ATTACHMENT 12

LARKIN PROPERTY
PRELIMINARY PLAT

UTILITY PLAN
10201 134TH AVE NE
LARKIN PROPERTY
PRELIMINARY PLAT
1246700141
CITY OF REDMOND WASHINGTON

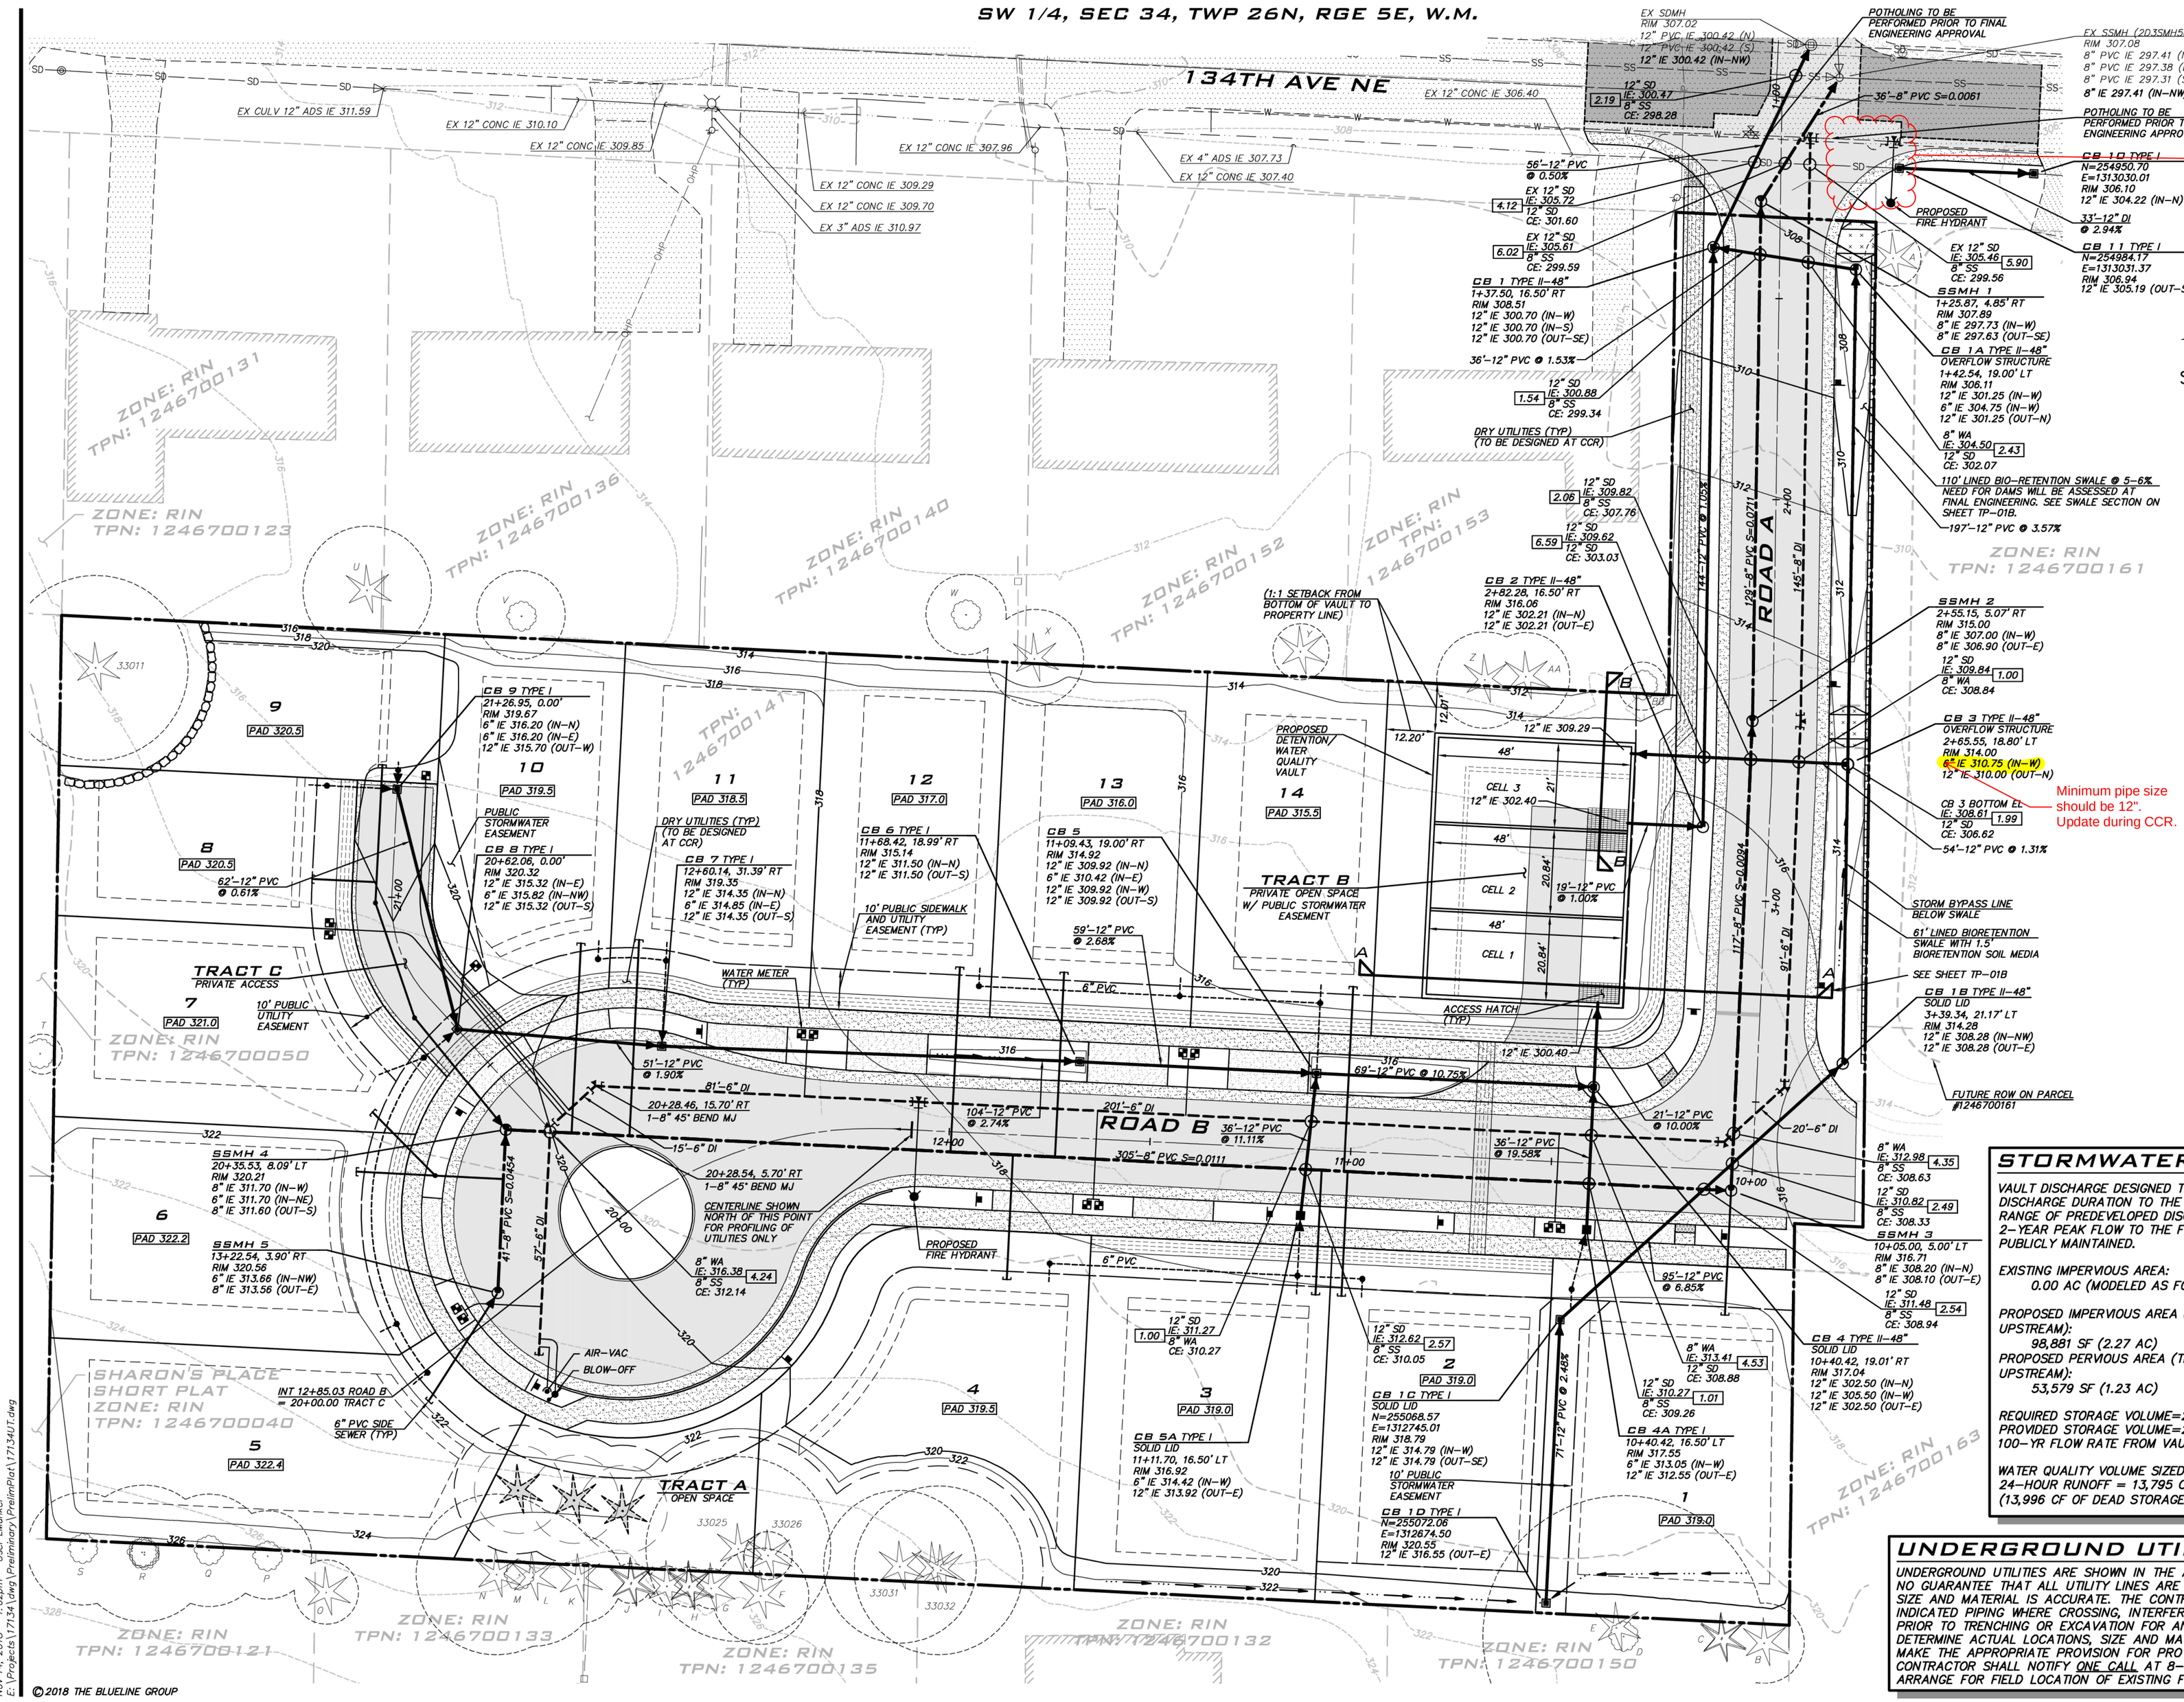
The developer needs to show the removal of the Fire Hydrant assembly. Need to remove the existing fire hydrant, blind flange the tee and put thrust block behind it. Install new fire hydrant assembly. HA

Minimum pipe size should be 12". Update during CCR.
